MINUTES *** MAY 12, 2022

1. MPL2022-10019 2ND WAVE APARTMENTS

Request for approval of a Specific Parcel Master Plan (SPMP) for 337 multifamily units and associated amenities on Parcels 2,3, and 4 of the 2nd Wave Apartments PD.

Staff Report to the Southeast Town
Design Review Committee
May 12, 2022

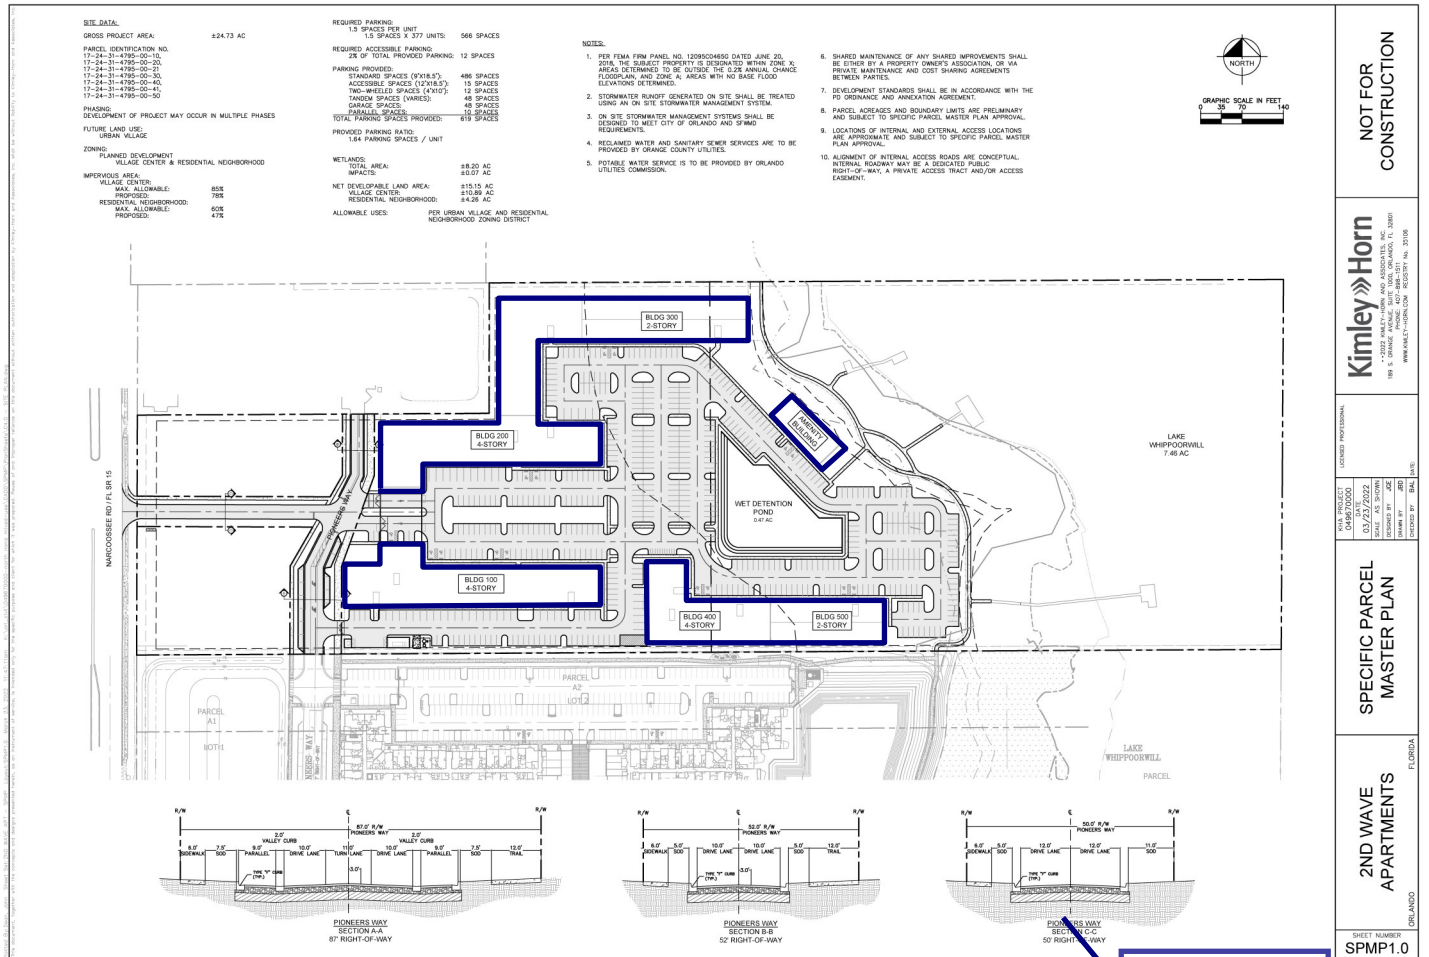
Site plan must be updated to reflect most recent status and circulation plan, including moving main gates eastward to create denied entry space.

Entry road, not
Pioneers Way

Spaces within ROW do not count toward site.

Total is 609

PIONEERS WAY
SECTION A-A
87' RIGHT-OF-WAY

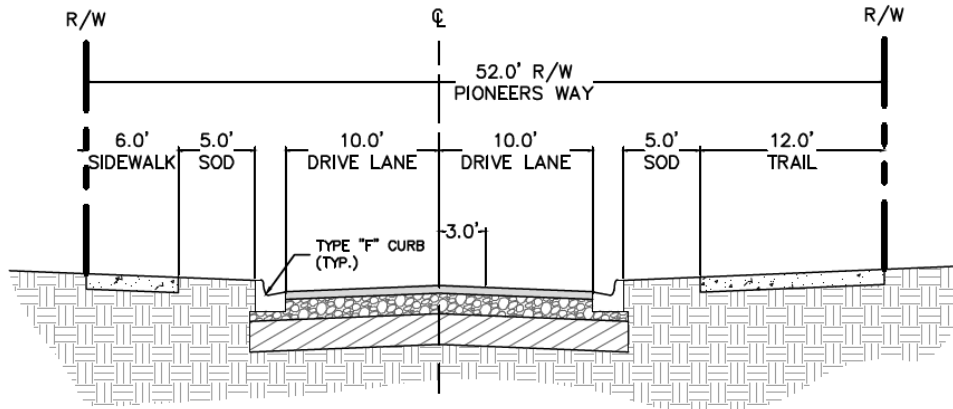
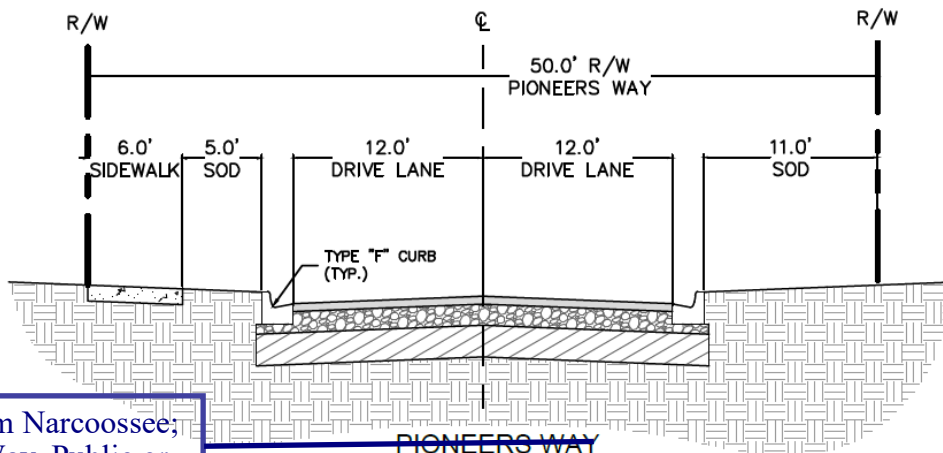
Cross-sections must be modified per Conditions of Approval.

7. Pioneers Way: The roadway must be revised to provide a smoother transition at the turns north and south of road C-C.
 8. Street Cross Sections:
 - a. Cross Section A-A: On-street parking may be reduced to 8 ft. in width with up 1 ft. of the parking space located within the gutter pan.

- b. Cross section C-C: Must be updated to include sidewalks along each side of the street.
 9. Main Entry/C-C Roadway and Pioneers Alignment: As designed there is a significant offset for vehicles crossing Pioneers Way at the intersection. The intersection must be revised to minimize the offset for vehicles traveling east or west through this intersection.

PIONEERS WAY
SECTION B-B
52' RIGHT-OF-WAY

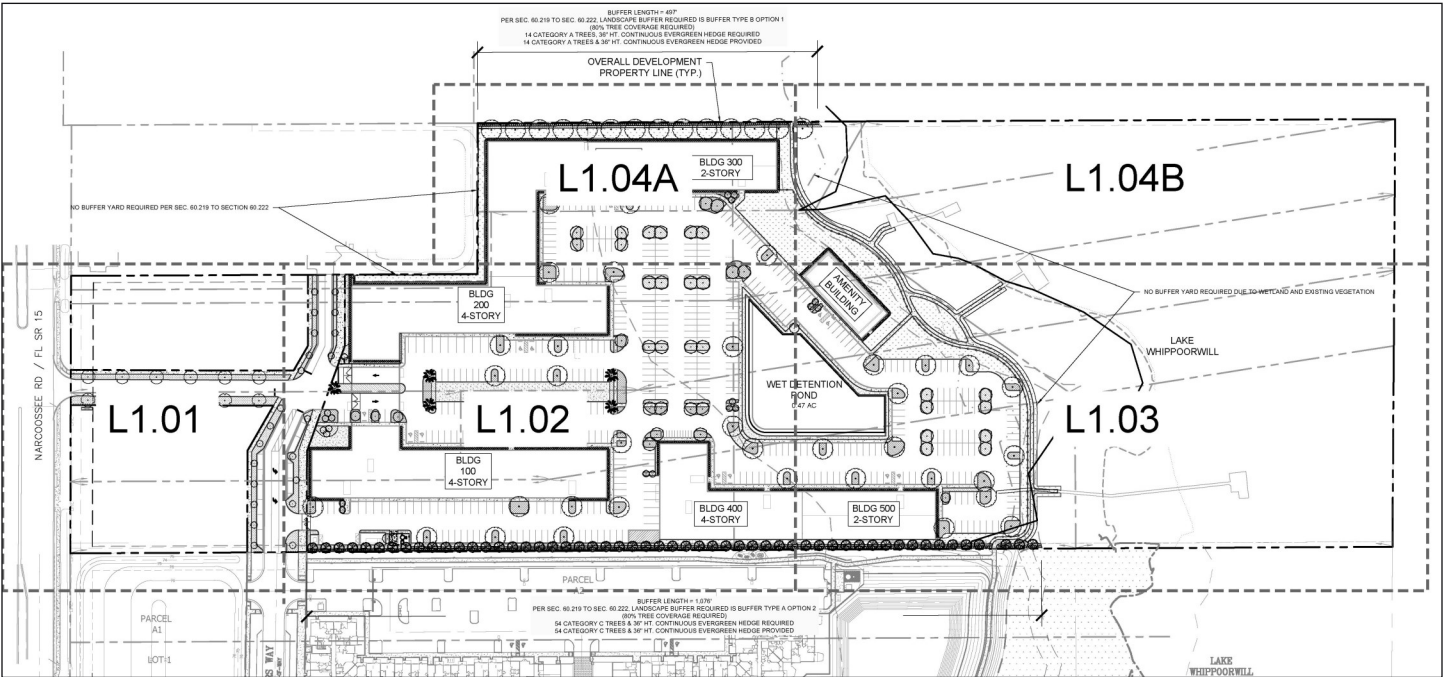
1. Streetscape B-B does not match the site plan north of the intersection at Pioneers Way. Street must be able to accommodate sidewalks and street trees on both sides of the street. The site plan shows a smaller landscape strip than what is shown on the cross-section. A minimum of 7.5 ft. of a landscape strip is required to accommodate the trees.
2. A 7.5 ft. landscape strip is required to accommodate the width of a street tree. This must be shown on both sides of the street.

ELEVATIONS

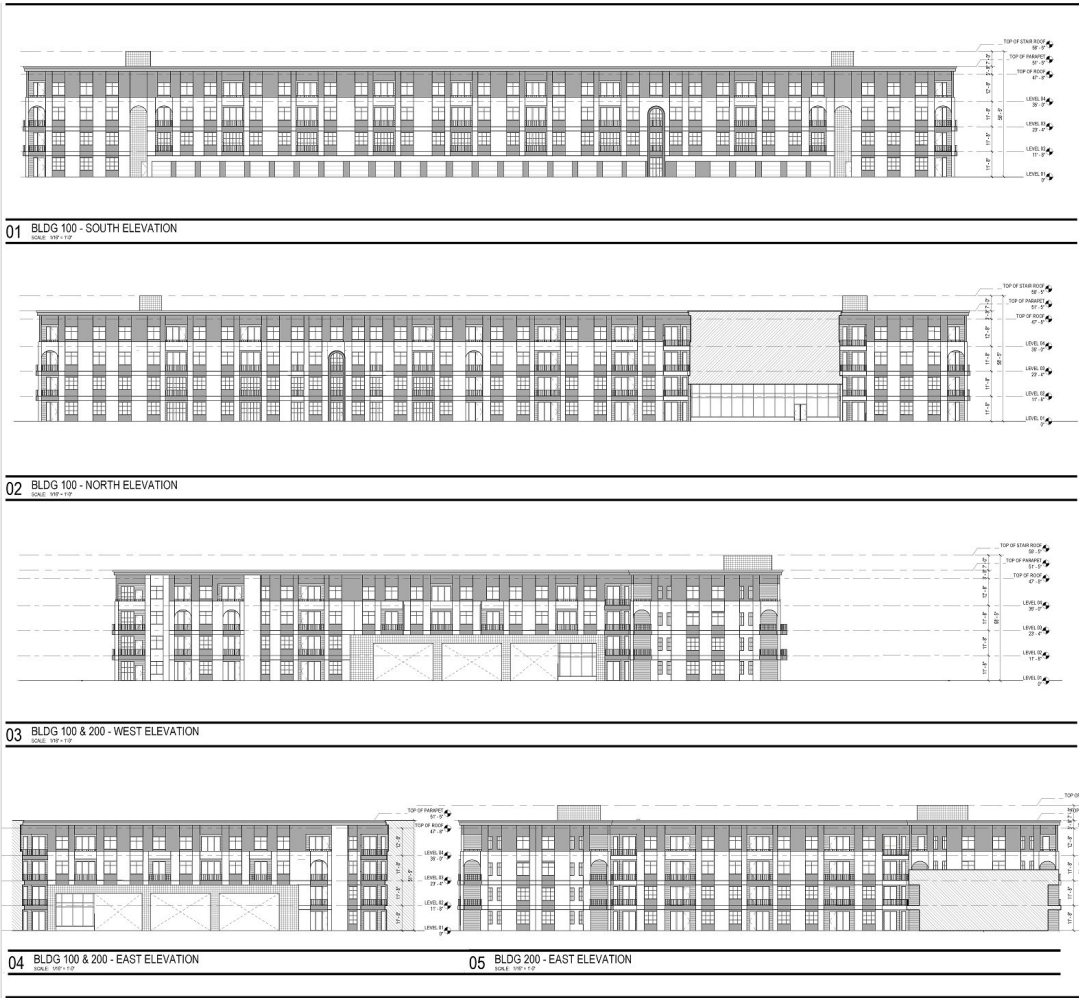
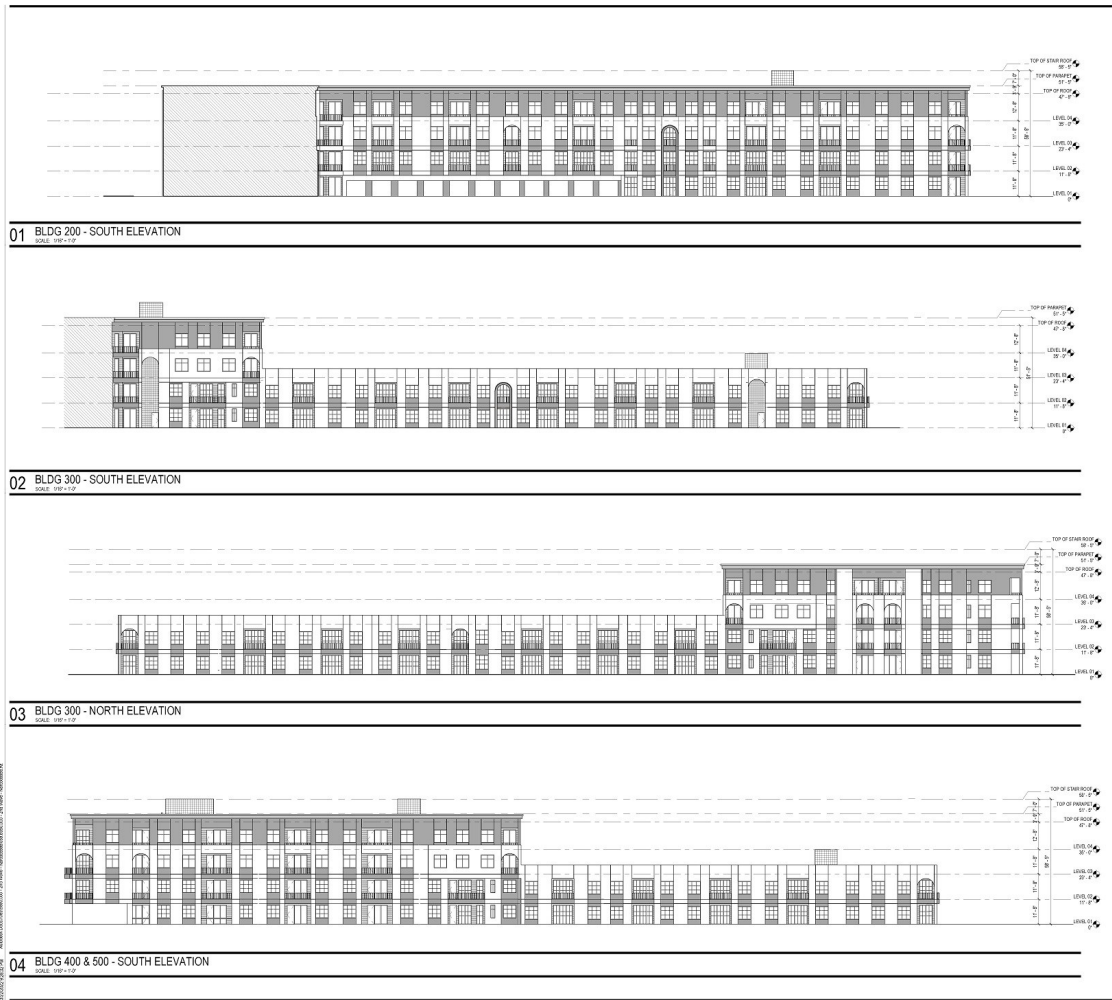
Elevations must be updated at time of Final Site Plan to reflect current site plan and renderings.
